TURKEY POINT NUCLEAR GENERATING UNIT 3

Amendment No. 5
License No. DPR-31

ATTACHMENT TO LICENSE AMENDMENTS NO. 5 AND NO. 4
CHANGE NO. 17 TO THE TECHNICAL SPECIFICATIONS
FACILITY OPERATING LICENSES NO. DPR-31 AND NO. DPR-41
FLORIDA POWER AND LIGHT COMPANY
TURKEY POINT NUCLEAR GENERATING UNITS 3 AND 4
DOCKETS NOS. 50-250 AND 50-251

SAFETY EVALUATION BY THE DIRECTORATE OF LICENSING
SUPPORTING AMENDMENT NO. 5 TO LICENSE NO. DPR-31, AND
AMENDMENT NO. 4 TO LICENSE NO. DPR-41
(CHANGE NO. 17 TO TECHNICAL SPECIFICATIONS)
FLORIDA POWER AND LIGHT COMPANY
TURKEY POINT NUCLEAR GENERATING UNITS 3 AND 4
DOCKETS NOS. 50-250 AND 50-251

Figure 2.1-1. Reactor Core Thermal and Hydraulic Safety Limits, Three Loop Operation

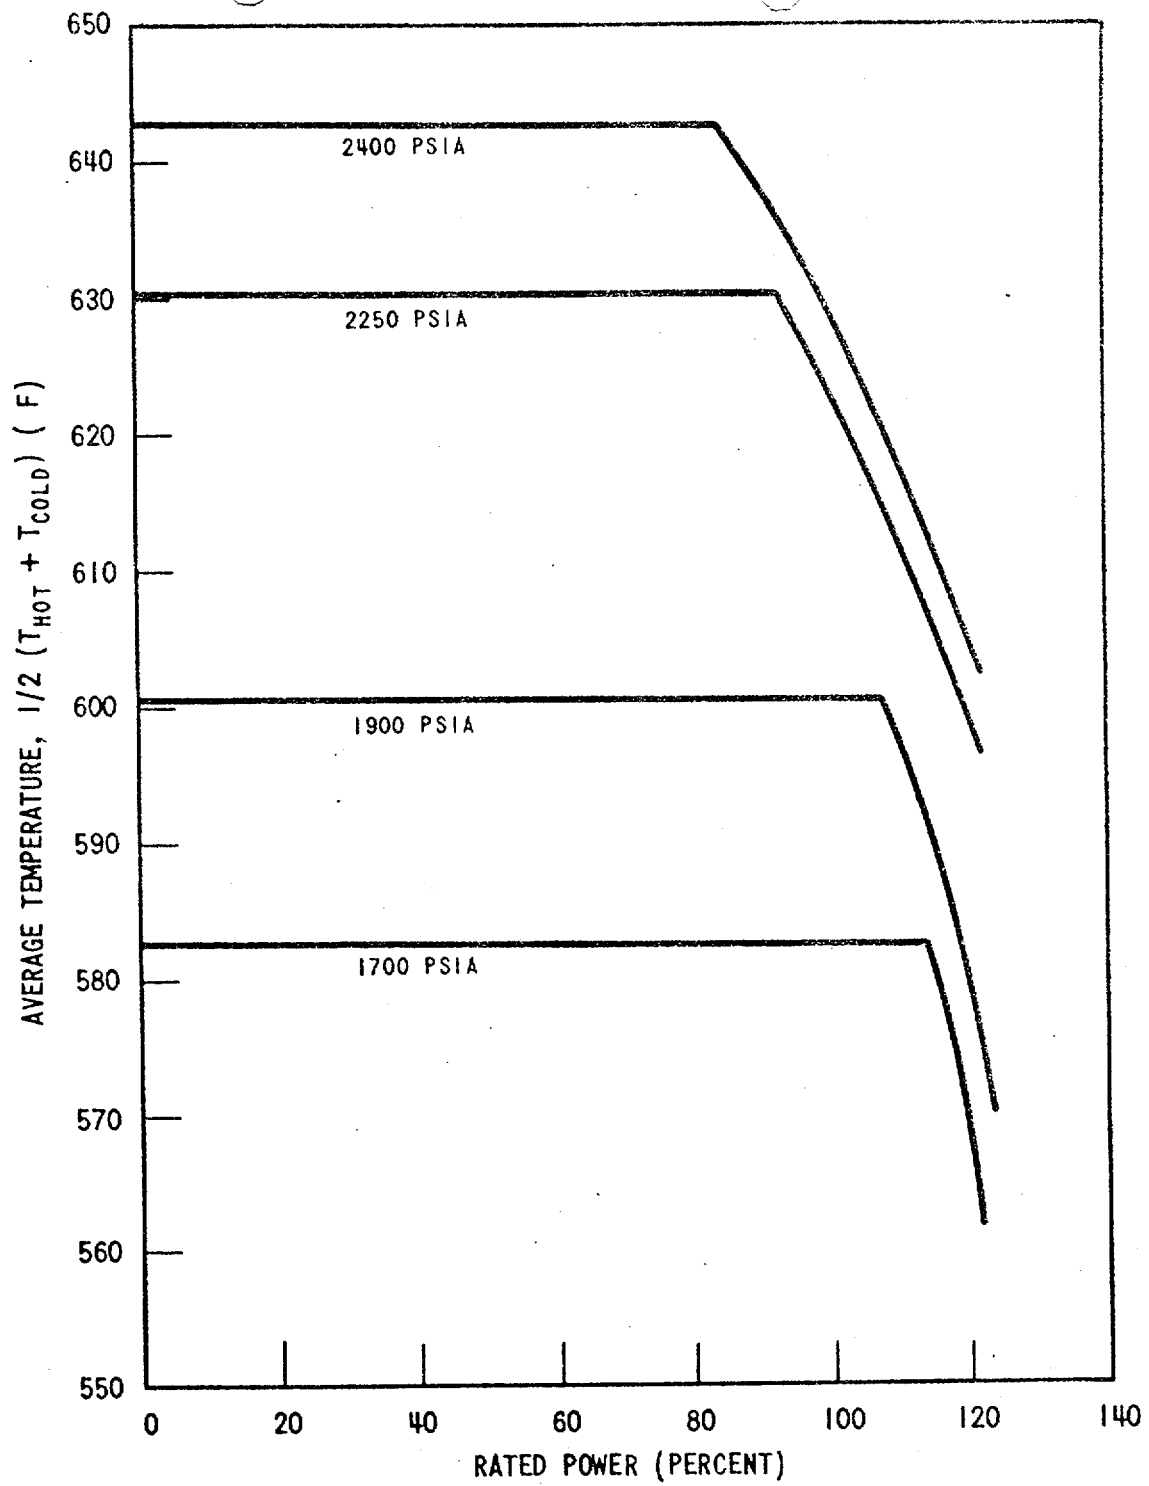
In order to make the present fuel residence limit applicable to Cycle 2, the references to Cycle 1 have been removed from the Technical Specifications figures which define core thermal and hydraulic safety limits for two loop and three loop operation.

Revise Appendix A as follows: Replace page 1-6 and Figures 2.1-1 and 2.1-2 with the attached pages.
